Exchange of propeller shaft on ROTAX® Engine type 912 / 914 (Series) and 912 i (Series)

ATA System: 72-10-00 Propeller gear assy.

SERVICE BULLETIN

Exchange of propeller shaft on ROTAX® Engine Type 912/914 (Series) and 912 i (Series).

Fig. 1

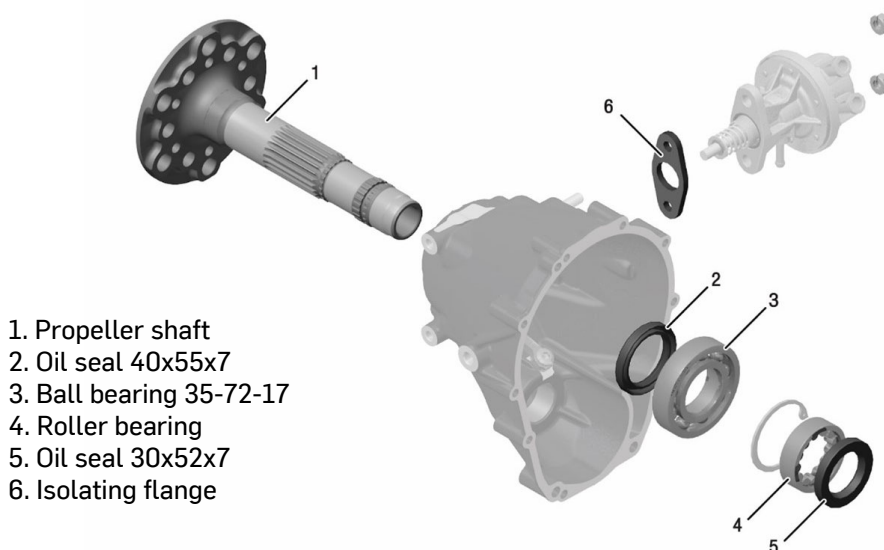
See Fig. 1.

Parts requirement in case of replacement:

Part no.	Qty/engine	Description	Application
937047	1	Propeller shaft	Version 2
832587	1	Ball bearing 35-72-17	Gearbox side
950470	1	Oil seal 40x55x7	Gearbox side
232246	1	Roller bearing	Crankcase side
950200	1	Oil seal 30x52x7	Crankcase side
950228	1	Isolating flange	Fuel pump (912 Series)

- Remove gearbox assy. from the engine
- Disassemble gearbox and press out affected propeller shaft
- Reassemble the gearbox using a new propeller shaft, oil seal and ball bearing
- Remove crankcase side propeller shaft roller bearing and oil seal and replace with new
- Attach gearbox assy. to crankcase
- In the case of an engine installed in an aircraft, perform an engine test run
